Staff Report

Infill Housing Design Review

File Number: 8-A-25-IH

Location: 3305 Savoy St. Parcel ID: 81 P A 012

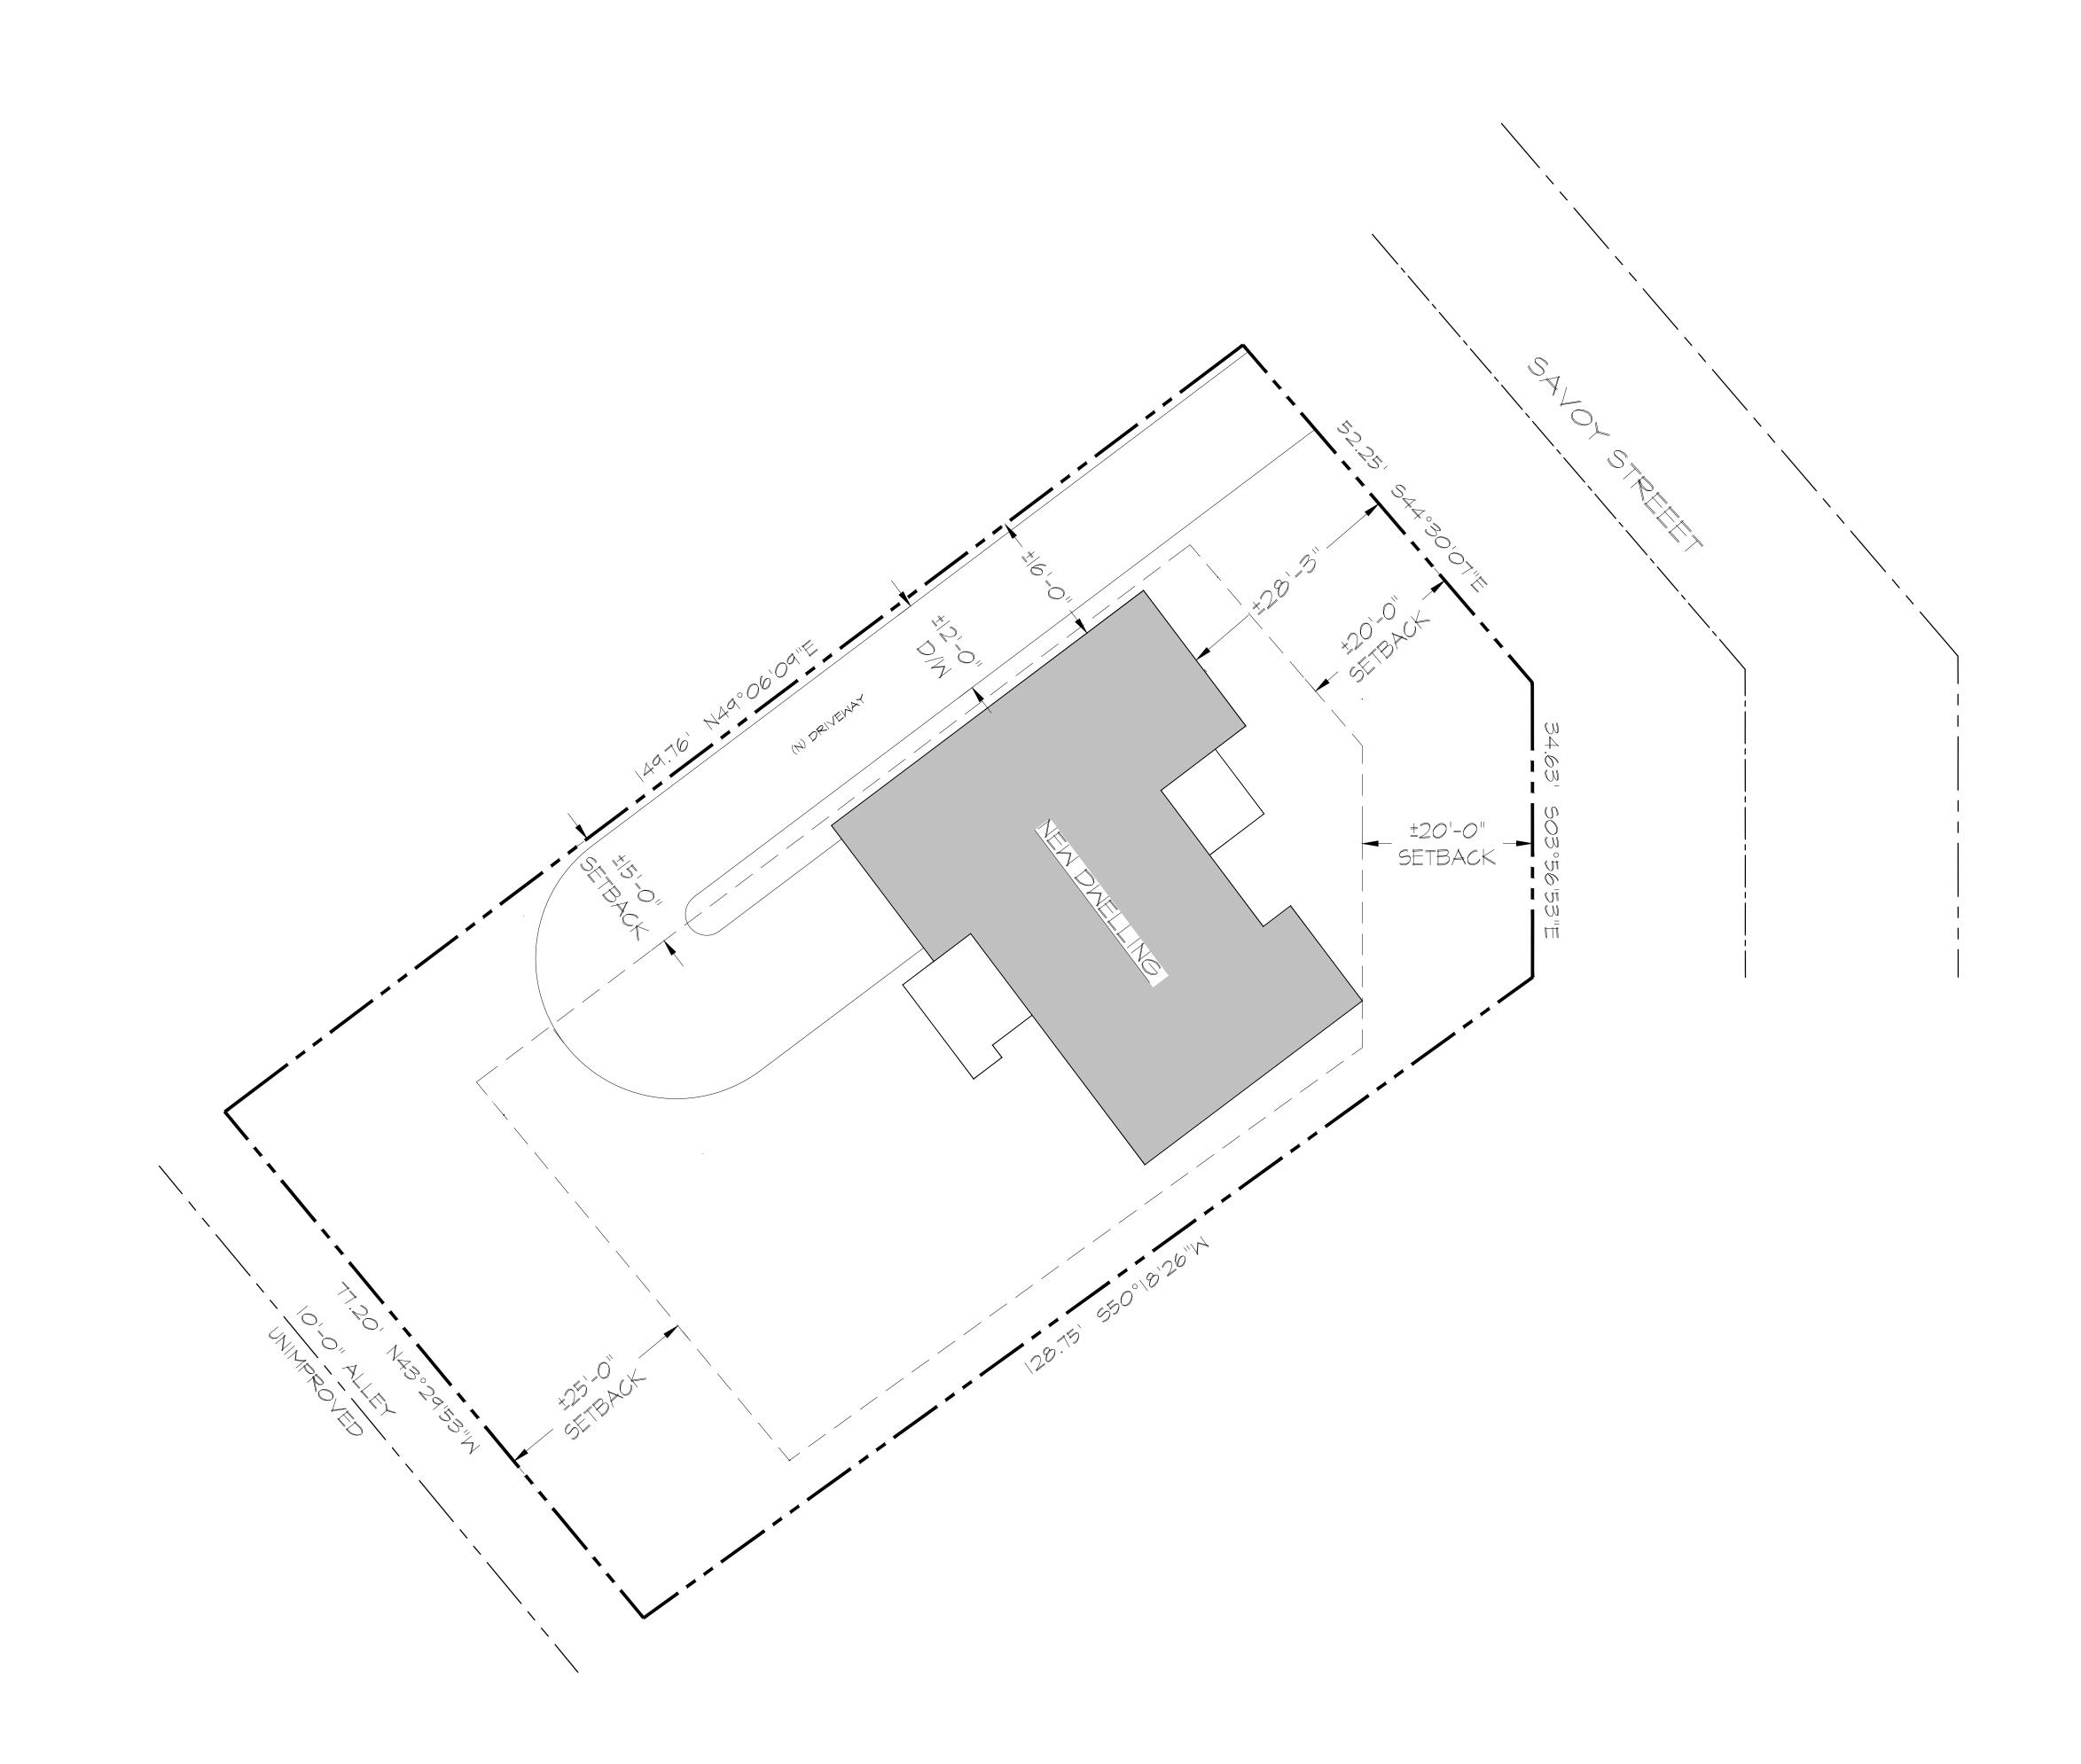
- 2. The average setback of the blockface is 24', with the adjacent house at 21'. The house is proposed to be set 28.3' from the front lot line, in part due to the road intersection and slope near the front lot line. The proposed front setback is appropriate. The final site plan should include a walkway from the porch to the street.

- 3. Parking is a concrete driveway accessed via Savoy Street that curves at the rear of the house to access a rearentry garage. The design guidelines state that "On streets without alleys, garages or parking pads should be at least 20 feet behind the front façade of the infill house with access limited to one lane between the street and the front façade." The proposed parking meets the design guidelines, and the final site plan should meet City Engineering standards.

- 4. Guidelines recommend that existing healthy trees on the site be preserved and protected during construction. The mature oak tree at the rear of the property should be preserved and protected, unless revisions to parking make removal necessary. The final site plan should include a native or naturalized shade tree in the front and rear yard.

Along with any necessary revisions or conditions, staff recommends approval of Certificate 8-A-25-IH, subject to the following conditions: 1) the final site plan to meet City Engineering standards; 2) parking be revised to avoid the front yard, with final location approved by staff; 3) the final site plan to contain a tree in the rear yard, with the mature oak tree in the rear to be retained unless revisions to parking make removal necessary; 4) a window be added to the left elevation; and 5) revised elevation drawings be provided formally showing the window on the right bay of the façade, which should feature the same design as the adjacent windows.

A2.0

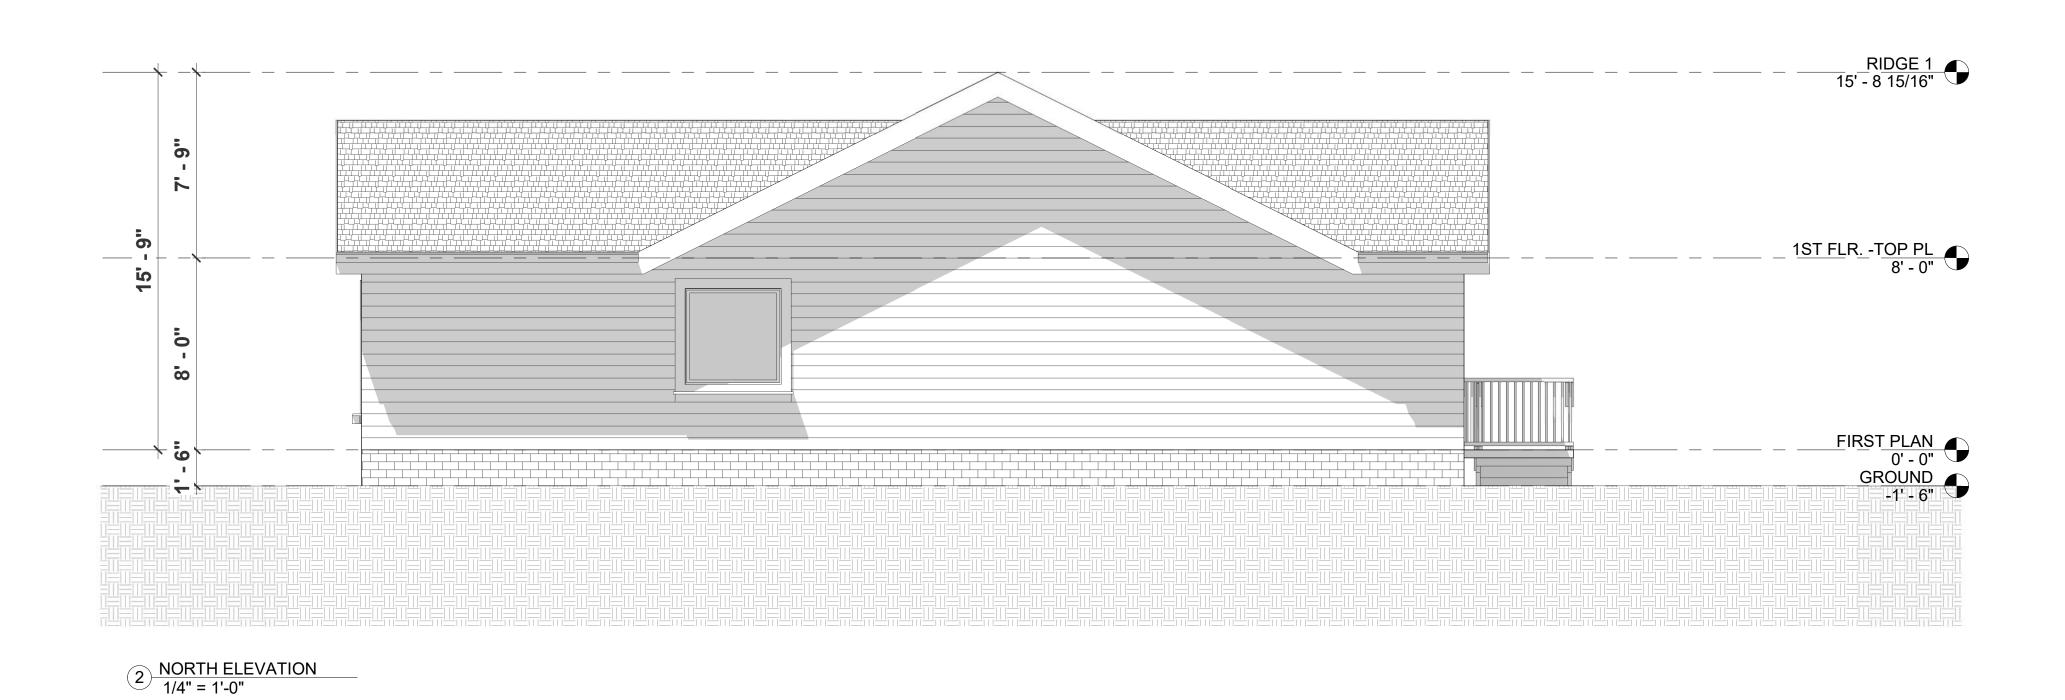
- 6. The four-bay, one-story façade is similar in height to the context, but it is wider in scale. The revisions to the right front-gable massing and front porch reduce the visual scale of the façade width from the previous proposal.

- 7. The design features a 9'-6" wide by 8' deep stoop recessed under a shed roof and supported by one square column. The guidelines recommend that new construction feature porches with proportions and supports similar to the context, allowing for stoops where porches are not traditional. The front porch is similar in scale to the infill construction present on the block and surrounding area, which primarily features partial-width porches. The porch post should be at least 8" by 8" to be compatible with the context. The Board should discuss whether an additional

post should be added.

- 8. Guidelines recommend window and door styles be similar to historic houses on the block with a similar ratio of solid to void. The proposed paneled front door is appropriate. The 1/1 single-hung and 1/1 single-hung windows are compatible with the context, and the façade, right, and rear elevation feature a sufficient ratio of solid to void. A window should be added to the left elevation to avoid a blank wall. The design benefits from the trim and sills. The styles of the windows and doors are inconsistent in the sketch and elevation drawings, but all proposed options are appropriate; final window and door selections should be approved by staff.
- 9. The 6/12 pitch side-gable roof is the minimum typically approved by the design guidelines.
- 10. The asphalt shingles, horizontal lap siding, and block foundation clad in brick veneer meet the design guidelines.
